SUBJECT: Draft Environmental Impact Report (DEIR) for The San Quentin State Prison Condemned Inmate Complex (CIC) Project dated September 27, 2004.

Letter 14

Response to Draft EIR for: San Quentin State Prison, Condemned Inmate Complex Project

Figure 1: Generalized Speed-Flow Relationships (TRR 1365, pp.13)

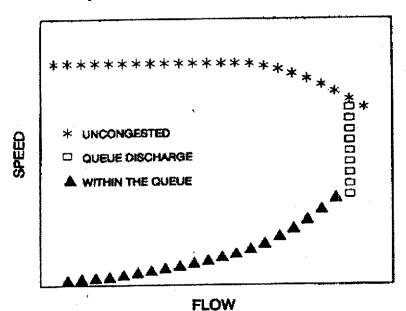
Many aspects of the EIR, Section 4.12, and Transportation are inadequate. The EIR contains confusing numerical information and lacks important data relating to traffic impacts due to expansion of Prison operations and construction of the CIC. The Scope of the EIR limits the traffic study to only those additional trips resulting from increased prisoner population. Though these trips are a small percentage of the current traffic totals in the area, they do create significant impacts. The Attached Speed-Flow Curve¹ shows that once traffic starts to slow, traffic flow rates diminish quickly. Many of the roadways and intersections in the project area are already operating with slowed traffic. Thus the addition of Project Trips can create significant impacts. The impacts include the wasting of human resources lost while stuck in traffic, the increase in air pollution resulting of autos idle ling, and the consumption of non-renewable fuels.

14-9 The comment states that the Draft EIR contains confusing numerical information and lacks data relating to traffic impacts, but no specific inaccuracies are identified. Because no specific issues pertaining to the analysis are identified, no further response can be provided.
